## E8802A-02

# S E R V I C E N O T E

## E8802A PNA Microwave Network Analyzers

**Figure 1:** A3 Front Panel Interface Board Assy without the Bracket

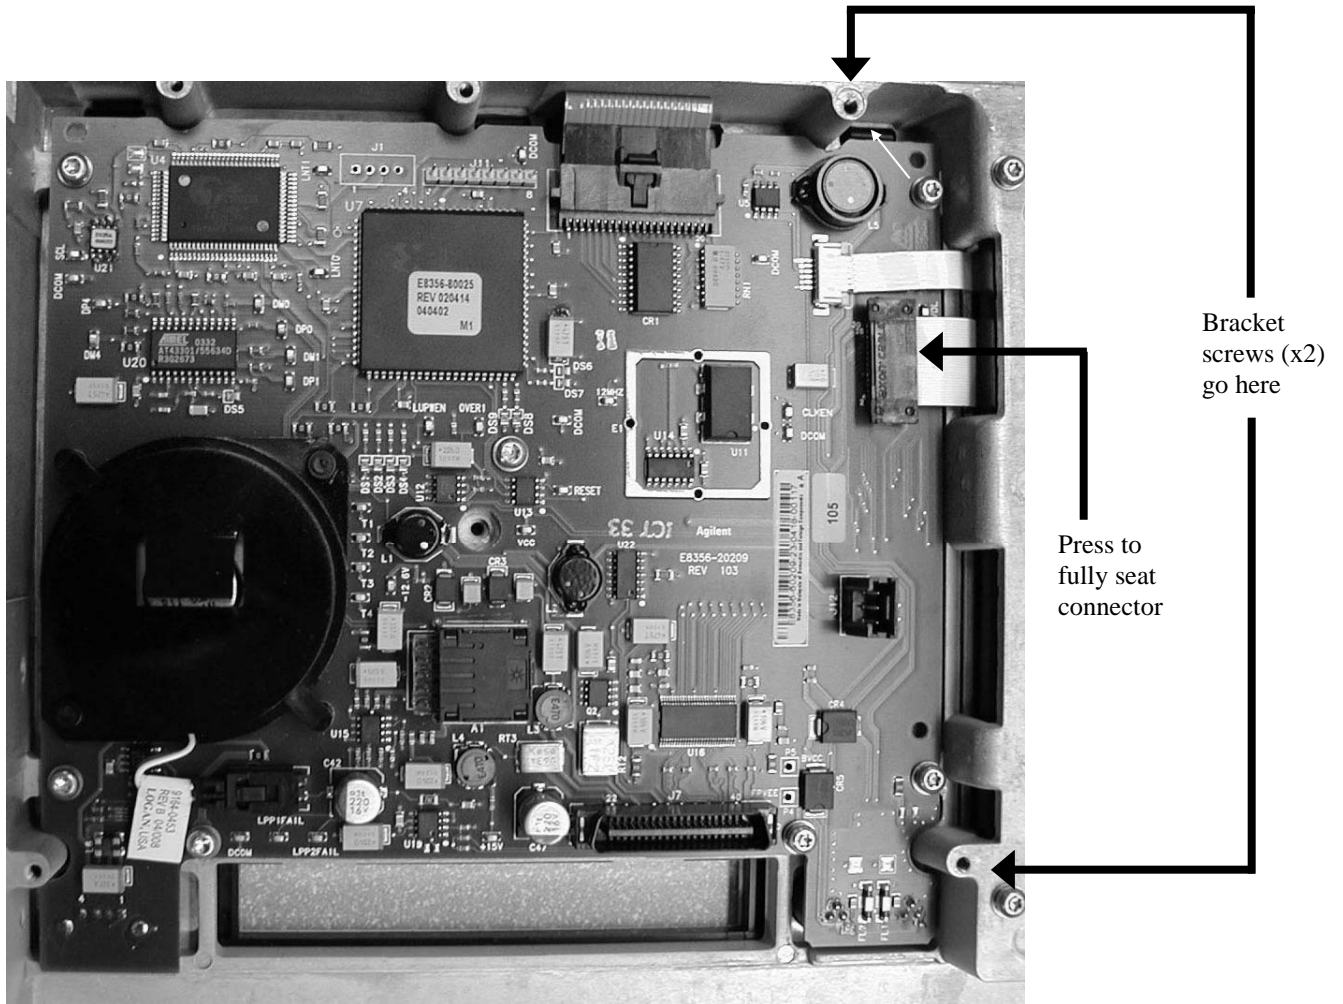
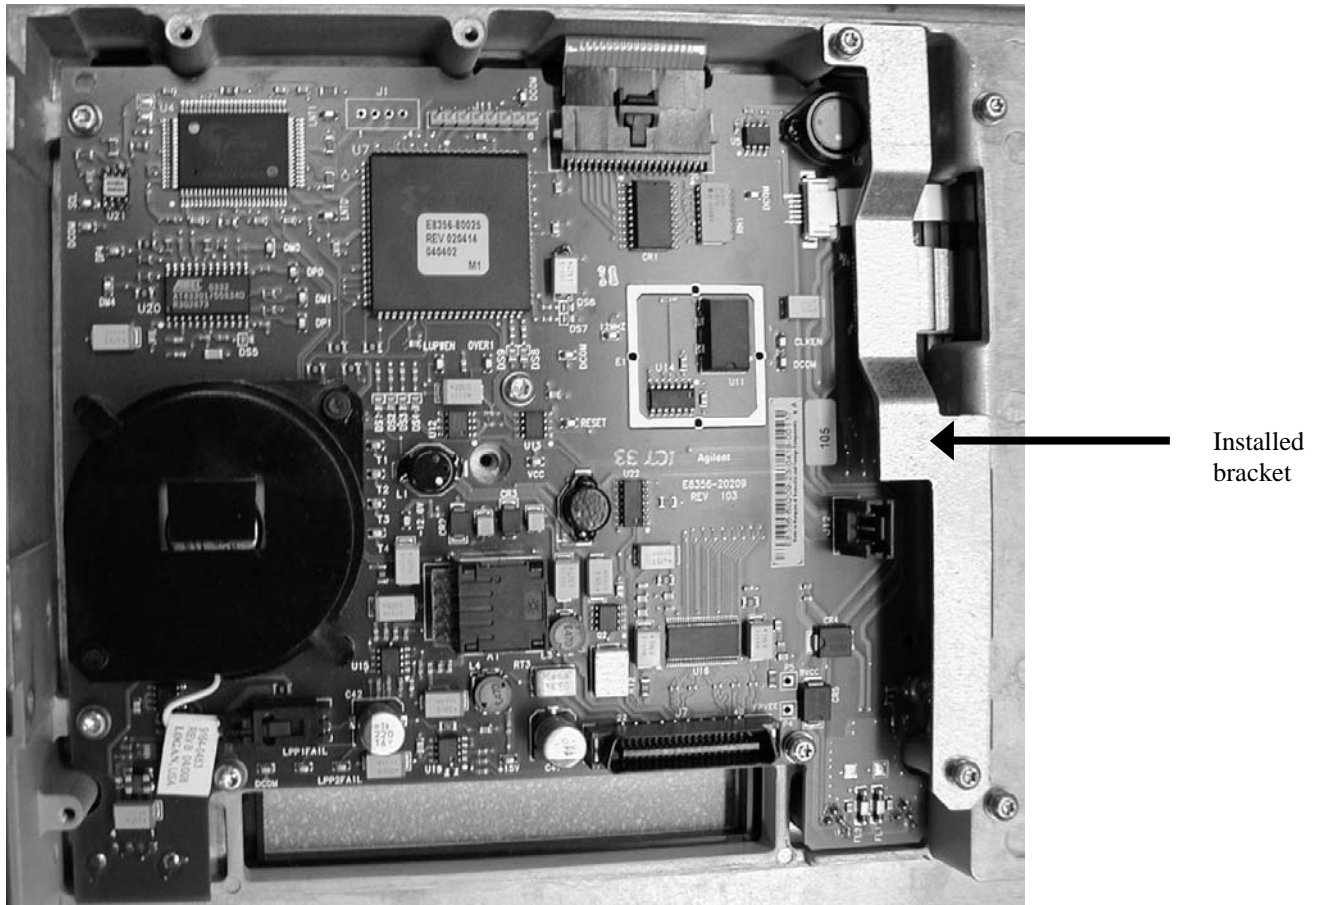
A connector of the ribbon cable (Agilent part number 8120-8409) that joins the front panel display to the front panel interface board can loosen, causing a display failure, unless a new bracket is installed. Because the failure rate has been very low, it is recommended that the bracket be installed only when there is an additional reason to remove the PNA front panel.

1. Refer to Figure 1 in this document:
  - Press down firmly on the ribbon cable's black connector.
  - Locate the two tapped holes for the bracket screws.
2. As shown in Figure 2 in this document, position the bracket so that its holes line-up with the two holes you located in the previous step.
3. Hand-start the two screws, and then torque both to 9 in-lbs.
4. Reinstall the PNA Front Panel by following the Service Guide instructions in the "Replacement Procedure." This is located on the same page as the "Removal Procedure" used previously in step 7.
